SUNDRY NOTICES AND REPORTS ON WELLS
Do not use this form for proposals to drill or to re-enter an abandoned well. Use form 3160-3 (APD) for such proposals.

8. Well Name and No.
SD EA 29 FED COM P8 9H

CHEVRON respectfully requests the ability to change the BOPE rating for the subject well, from a 5M system to a 10M system while drilling the production sections that penetrate the Wolfcamp formation. (All intermediate sections, which TD in the Bone Spring, will have the previously submitted 5M system setup).

BLOWOUT PREVENTOR SCHEMATIC

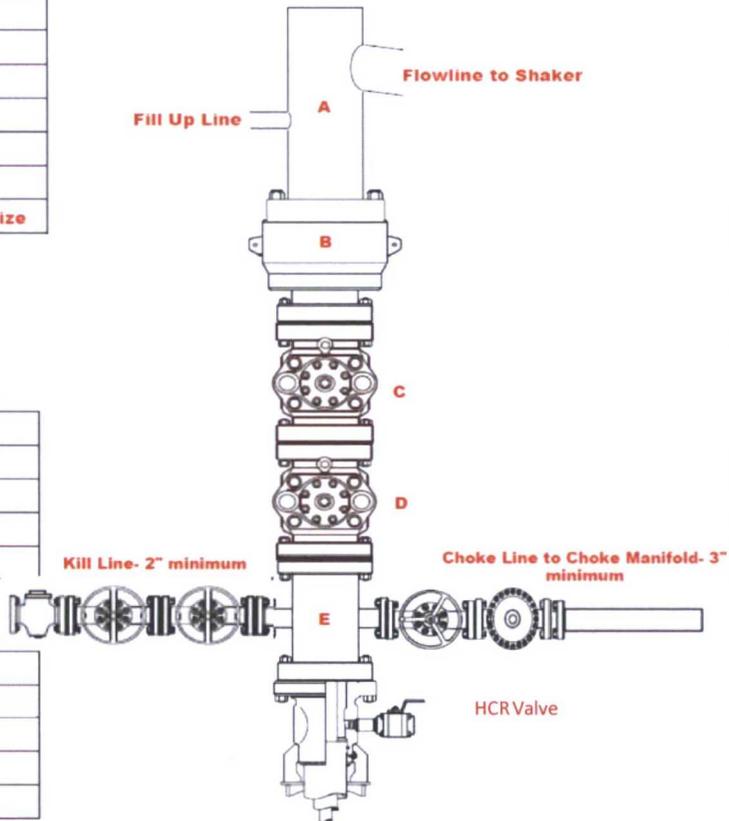
*All equipment will be 5M as per the original submittal, but the annular will be 10M, as well as the necessary upgrades to the choke manifold (Upgrade 2" choke lines to 3" with a third choke)

Minimum System Pressure Rating : 10,000 psi
